Subject: Sterling Ranch Filing No. 2 Final Plat, Review #3 (SF-20-015)

The Park Operations Division of the Community Services Department has reviewed the Sterling Ranch Filing No. 2 Final Plat, Review #3, and has the following additional comments of behalf of El Paso County Parks:

**Sterling Ranch Filing No. 2
Final Plat Review**

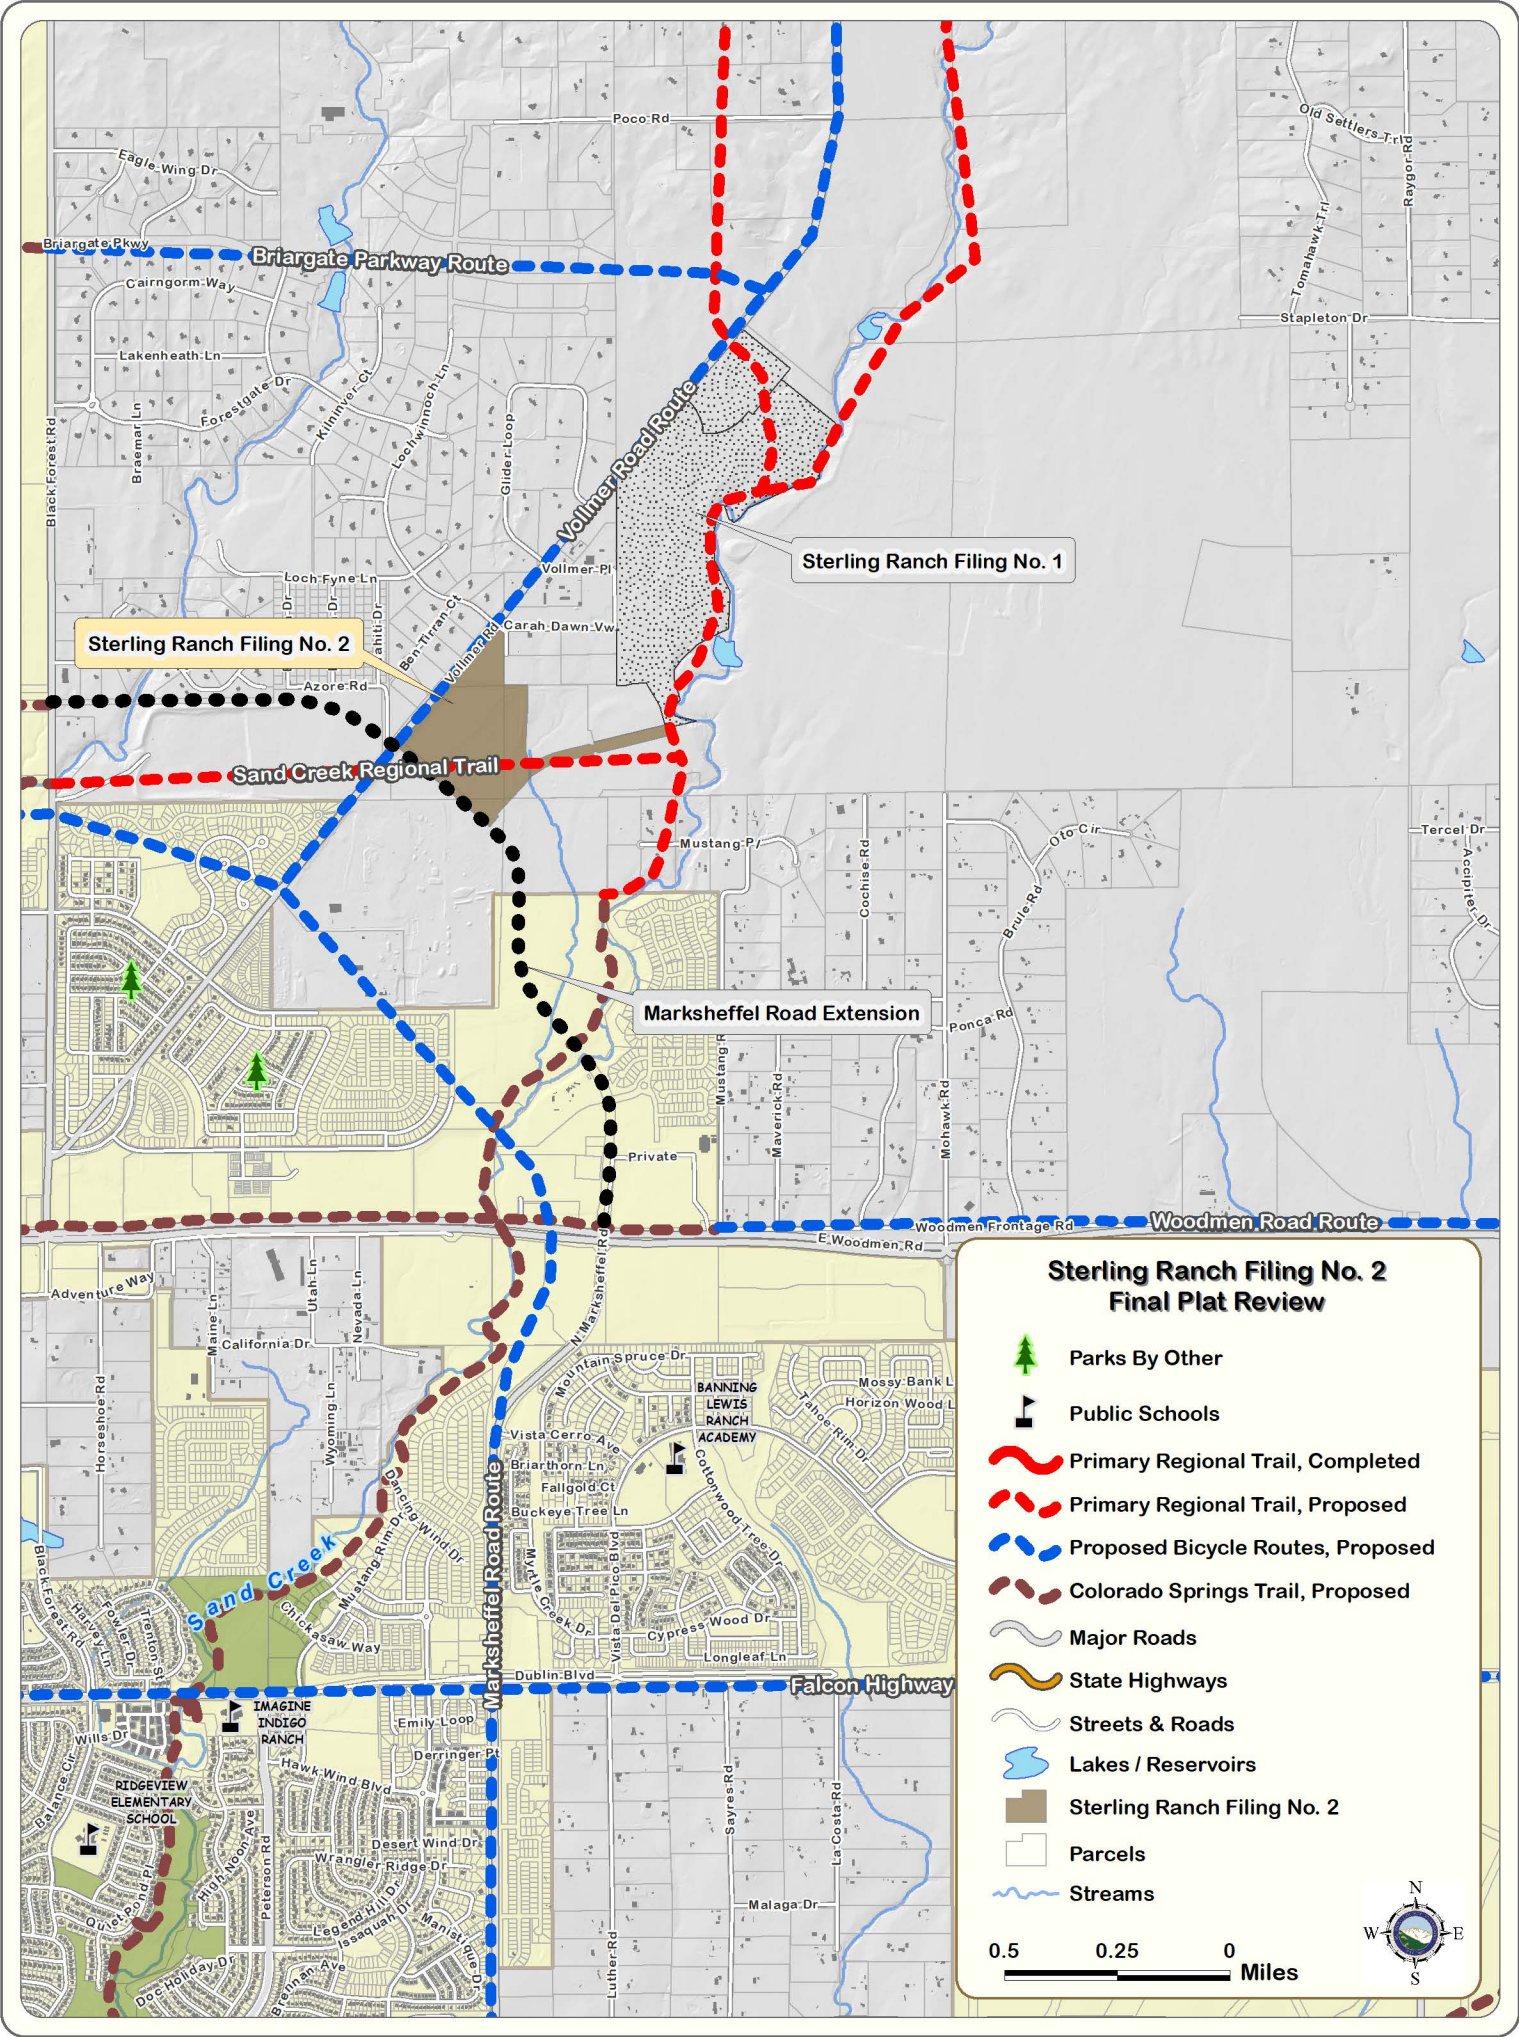
At this time, El Paso County Parks recommends that the applicant address the 25' trail easement located along the north side of Marksheffel Road, as recommended to and endorsed by the Park Advisory Board in February 2018. The trail easement is not shown on the submitted Final Plat, nor is it included in the Final Plat General Notes section. The additional 5' crusher fine trail is not depicted in the submitted Landscape Plans. These recommendations are highlighted below.

Staff recommends that the developer install a 5-foot wide gravel trail adjacent to the sidewalk on the proposed extension of Marksheffel Road on the street side to accommodate equestrians who may be accessing the Sand Creek Regional Trail from locations to the west, as well as dedicate to El Paso County a 25-foot wide trail easement for public access and maintenance of the trail. Staff also recommends fees in lieu of land dedication for regional and urban park purposes, the latter of which is required due to the fact that the original Preliminary Plan met the urban density requirements.

Recommend to the Planning Commission and the Board of County Commissioners that approval of Sterling Ranch Filing No. 2 Final Plat includes the following conditions: (1) recommend the developer install a 5-foot wide gravel trail adjacent the sidewalk along Marksheffel Road; (2) show on the Final Plat and dedicate to El Paso County a 25-foot trail easement along the north side of Marksheffel Road that allows for public access, as well as maintenance by El Paso County of the western branch of the Sand Creek Primary Regional Trail; (3) require fees in lieu of land dedication for regional park purposes in the amount of **\$22,883 (updated 07/16/2020)** and urban park fees in the amount of **\$14,455 (updated 07/16/2020)**.”
